**RE: Cypress Woods RV Resort PD  
DCI2020-00002**

Enclosed please find responses to Staff's comments dated October 3, 2019. The following information has been provided to assist in your review of the petition:

**ZONING REVIEW by Brian Roberts, P.E.**

**CYPRESS WOODS RV RESORT PHASE 5 RECREATIONAL VEHICLE PLANNED DEVELOPMENT**

SEC: 11 TWP: 44 RGE: 25E  
City: FORT MYERS County: LEE  
Designed by: CURTIS WICKSTROM  
Drawn by: CURTIS WICKSTROM  
Date: APRIL 2020  
Horizontal Scale: 1" = 200'  
Vertical Scale: N.T.S.  
Project Number: P-L26-001-001  
File Number: P-L26-002-001-X06  
**X06-IND**  
Sheet Number: 1 of 1

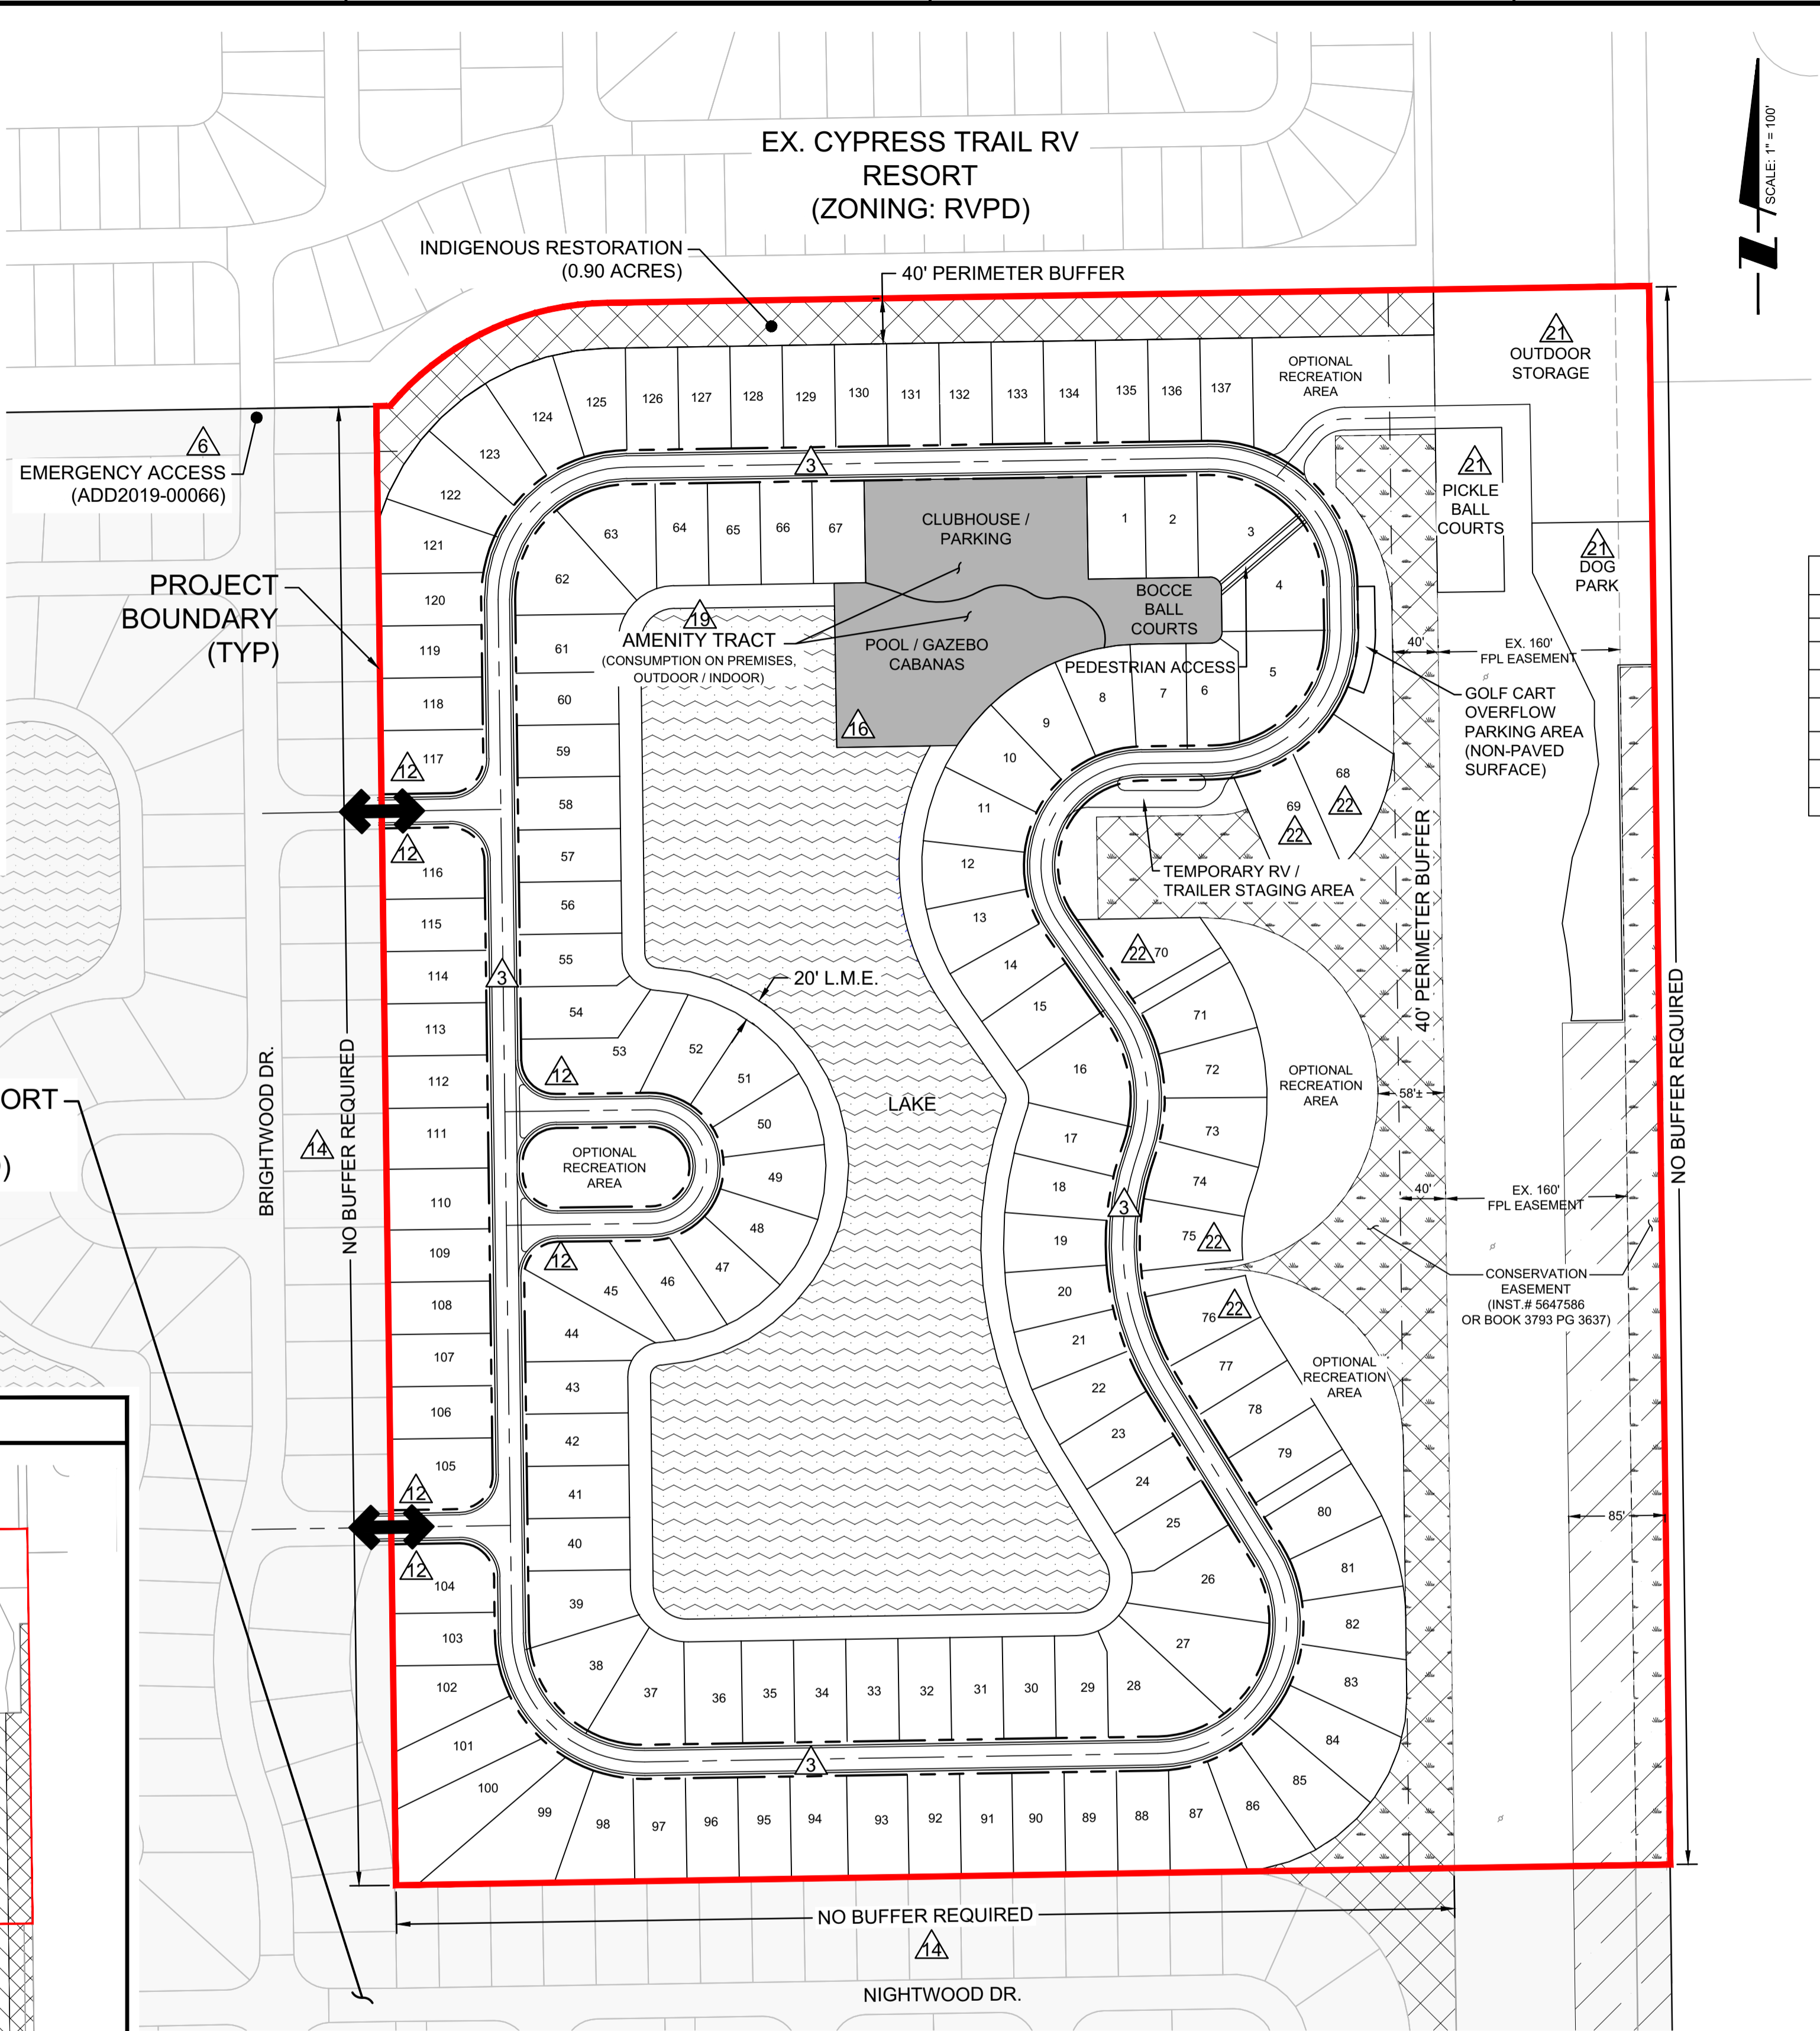
3. Sheet X06, 1 of 1, shows trailer parking, dog park and pickle ball courts outside of the 40' perimeter. This has the effect of allowing open storage and other uses without the required buffering. Please clarify.

**RESPONSE: Please refer to the revised Schedule of Deviations. Deviation 21 has been requested to locate certain accessory uses outside of (east of the) the 40' buffer RV buffer.**

TYPICAL LOT DETAIL

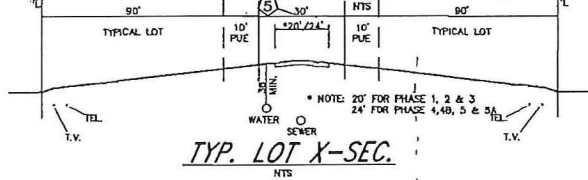
14. The proposed property development regulations show a 0/5 feet for a RV or accessory structure where a minimum separation of 10 feet between RVs and accessory structures. Please clarify how that 10' separation is maintained. Based on the typical lot drawings an RV could be parked as close to 5 feet from a casita.

**RESPONSE: Please refer to the revised Site Development Regulations, which have been corrected for consistency with the RV Lot Detail on Sheet 4 of the MCP.**

TYPICAL LAKE SECTION

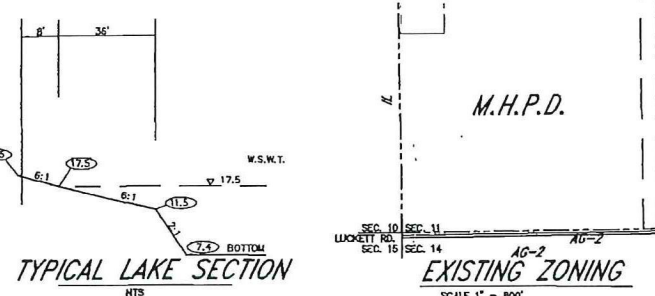
8. Please provide a lake cross section on the MCP for Phase 5.

**RESPONSE: Please refer to Sheet 4 of the MCP. A lake cross section has been provided.**
